# DRC SUBMITTAL FOR NEW MULTIFAMILY PROJECT

## FLAGLER 626 626-636 NE 1ST AVENUE

# **DEVELOPMENT REVIEW COMMITTEE (DRC) COMMENT REPORT**

**Request: Site Plan Level III Review: Conditional Use for Building Height in RAC-UV; 99 Multifamily Units**

1 SITE PLAN N  
A-002 scale: 1 = 20

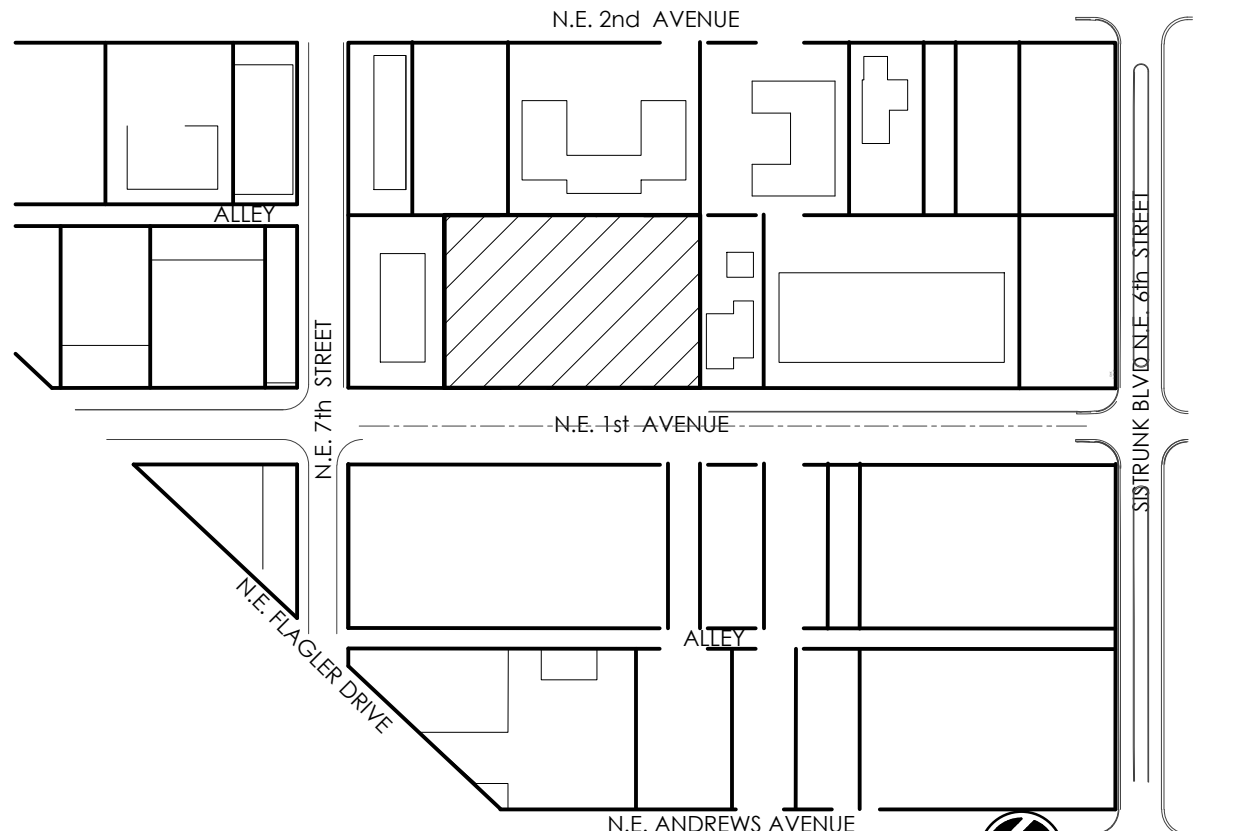
5. Drawing A-002: Width of proposed driveway should match 20' dimension shown on Drawing A-101.
6. Drawing A-101: 20' length for on-street parallel parking 'end' stalls allowable along NE 1<sup>st</sup> Avenue, adjacent to 45 degree angled pavement for parking stall access.

8. Drawing A-101: Label driveway grade into parking garage, which appears to ramp-up (or down) just beyond 7' sidewalk.
9. Label Drawing A-002 'Overall Site Plan' and Drawing A-101 'Site Plan'. Site Plan typically features all critical dimensions for the proposed development, such as building setbacks, parking lot access, sidewalk

**1 EXTERIOR NORTH ELEVATION**  
A-204 scale: 1/8" = 1'-0"

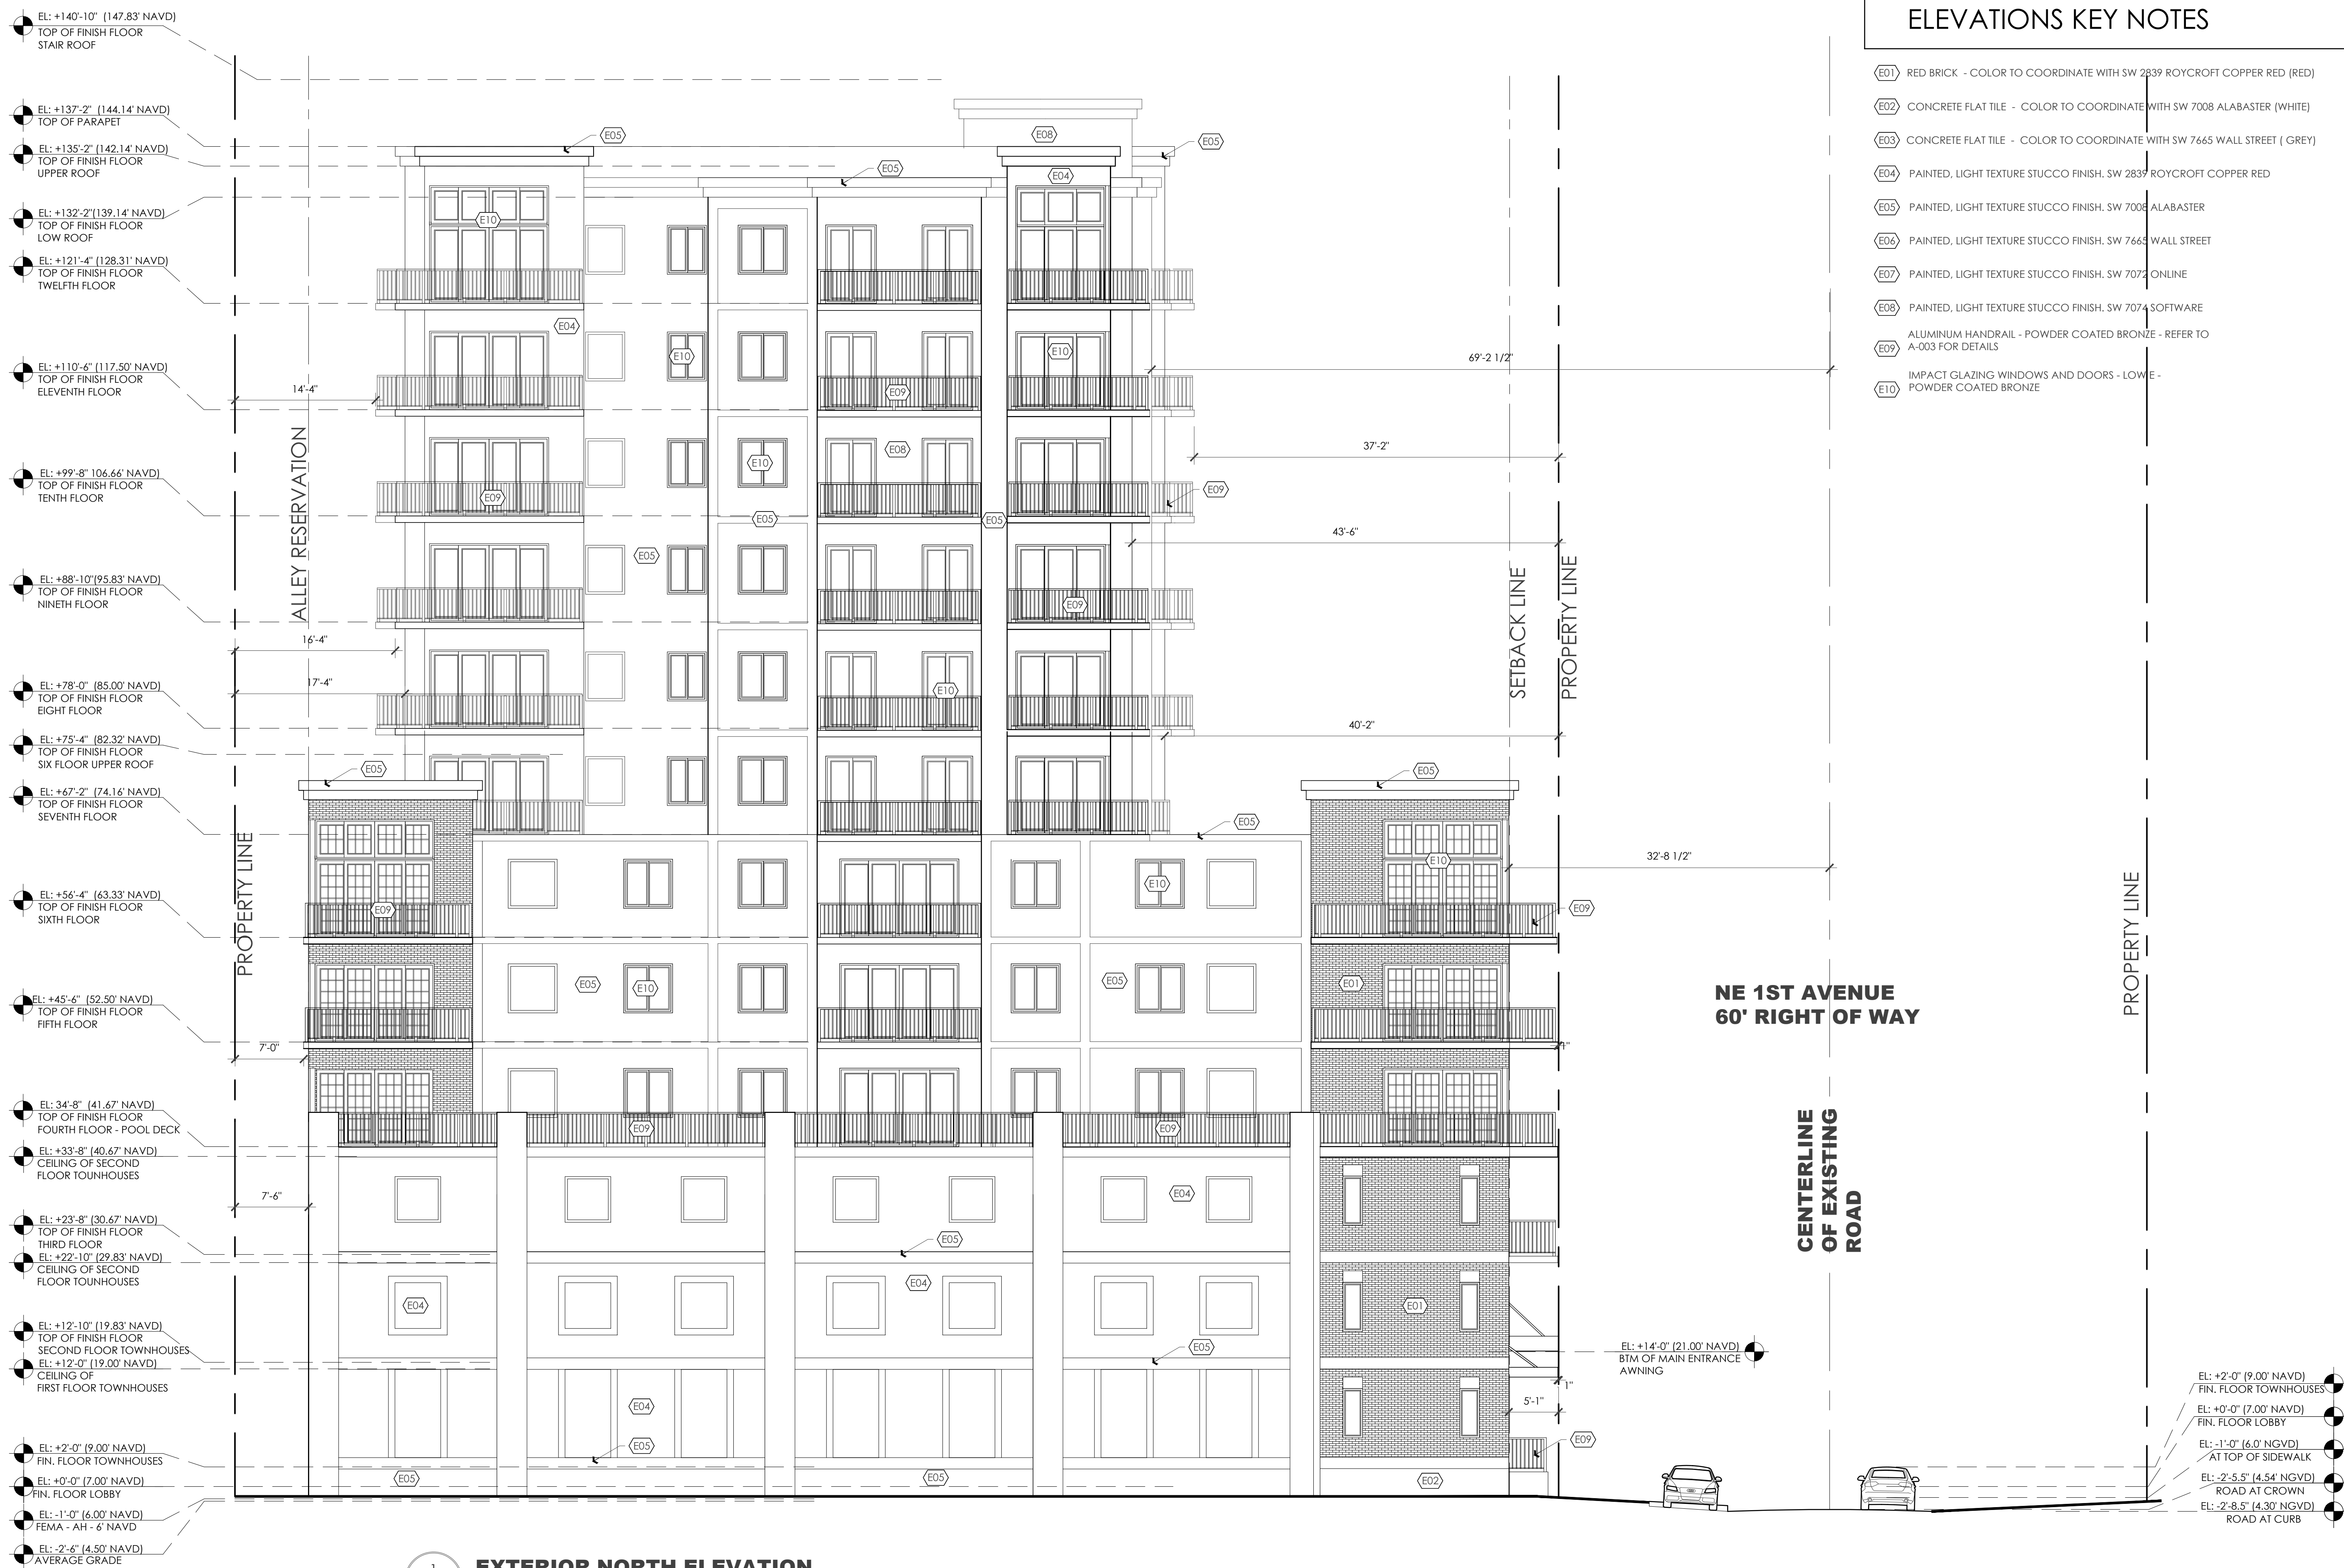
13. Drawing A-202 & A-204: Based on Boundary Survey, NE 1<sup>st</sup> Avenue half Right-of-Way width should be 30'.
14. Per ULDR Section 47-2.2.Q, show and label sight triangles as appropriate for safe and adequate access of drivers and pedestrians, on the Site Plan, Landscape Plans, and Civil Plans: intersections of driveways with streets (measured from pavement edges), alleys with alleys (measured from property lines extended), alleys with streets (measured from property lines extended), and streets with streets (measured from property lines extended). Per ULDR Section 47-19.1.E, no accessory use or structure shall be permitted within a sight triangle except as provided in [ULDR Section 47-35](#).
